Project	IEEE 802.16 Broadband Wireless Access Working Group < http://ieee802.org/16 >	
Title	OFDMA ranging	
Date Submitted	2004-03-11	
Source(s)	Jaehawk Lee, Jaeweon Cho, Sijun Cho Samsung electronics. Co. Ltd. Dong Suwon P.O.Box 105, 416, Maetan-3Dong, Yongtong-Gu, Suwon-City, Gyeonggi-Do, Korea 442-600	Voice: 82-31-279-3791 Fax: [Fax Number] [mailto:jaehawk.lee@samsung.com, jaeweon.cho@samsung.com, sijun.cho@samsung.com]
Re:		
Abstract	OFDMA ranging process is proposed.	
Purpose	Adoption of the proposed OFDMA ranging process into 802.16-REVd	
Notice	This document has been prepared to assist IEEE 802.16. It is offered as a basis for discussion and is not binding on the contributing individual(s) or organization(s). The material in this document is subject to change in form and content after further study. The contributor(s) reserve(s) the right to add, amend or withdraw material contained herein.

OFDMA ranging

Proposed Text Changes

[Replace the section “8.4.7 OFDMA ranging” with the following text]

Figure 1 – Initial and HO ranging transmission for OFDMA

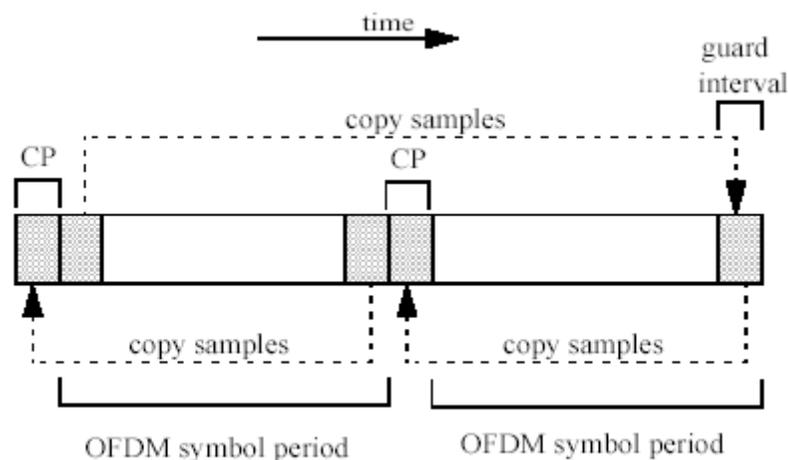
The initial ranging transmission shall be used by any SS that wants to synchronize to the system channel for the first time while and HO ranging transmission shall be used by any SS that wants to synchronize to other BS while in the HO process. An initial ranging and HO ranging transmission shall be performed during first two consecutive symbols in the up link frame using minimum of 32 tones. The same ranging code is transmitted on the ranging channel during each symbol, with no phase discontinuity between the two symbols. A time-domain illustration of the initial ranging and HO ranging is shown in Figure 1.

Figure 2 – Periodic ranging or bandwidth request transmission for OFDMA

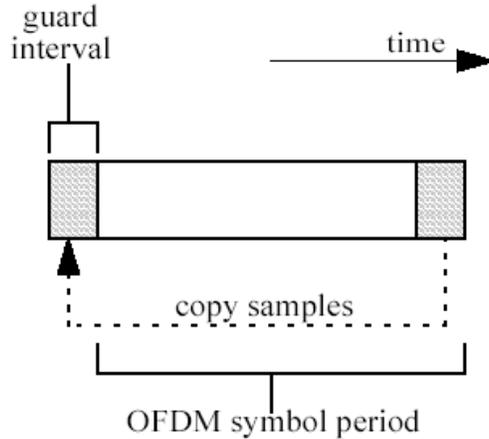
To perform either a periodic ranging or bandwidth request transmission, the SS shall modulate randomly selected one ranging code on the minimum of 32 ranging tones for a period on one OFDMA symbol immediately following initial ranging symbols in the uplink frame. A time-domain illustration of the periodic ranging or bandwidth-request transmission is show in Figure 2.

Figure 3 – PRBS for ranging code generation

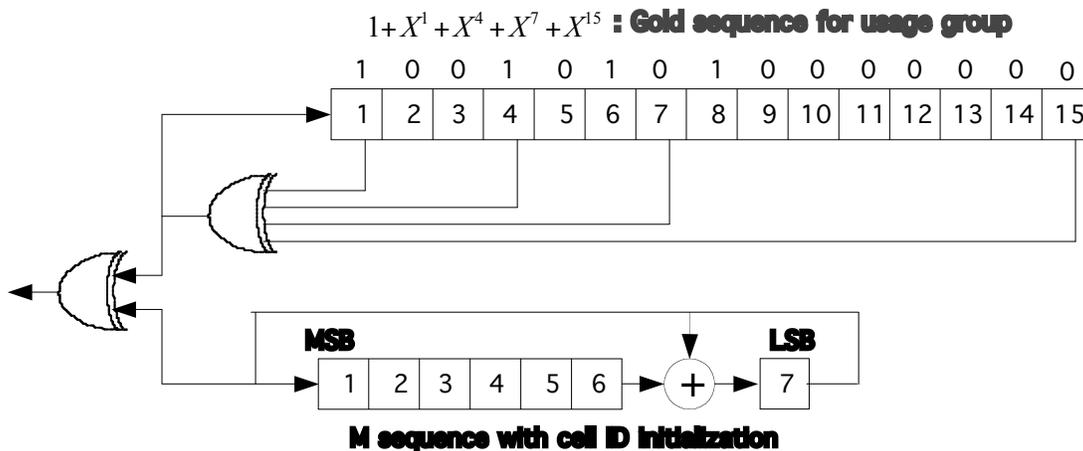
Figure 3. The codes for each ranging channel (initial, HO, BR and periodic) is generated by the polynomial $1 + x^1 + x^4 + x^7 + x^{15}$ and the PN mask for cell identification is generated by a M-sequence generator. The binary ranging codes are subsequences of the pseudonoise sequence appearing at its output. The length of each ranging code is minimum 32 bits to maximum 256 bits.

The first K 256 bit code obtained by clocking the PN generator as specified is used for initial ranging. The next L ranging code produced by taking the output of the $(256xK+1)^{th}$ to $(256x(K+L))^{th}$ clock of the PRBS is used for HO ranging. Following the HO ranging code, the next M codes each of length 256 bits are used for periodic ranging and the next N codes are used for bandwidth

requests. Each ranging code is masked by the cell specific code before transmission. This masking code is a M-sequence depicted in Figure 3. The M-sequence generator register is initialized by 7 bits cell identification number. The cell identification number is a system parameter which is indicated in the SICH.
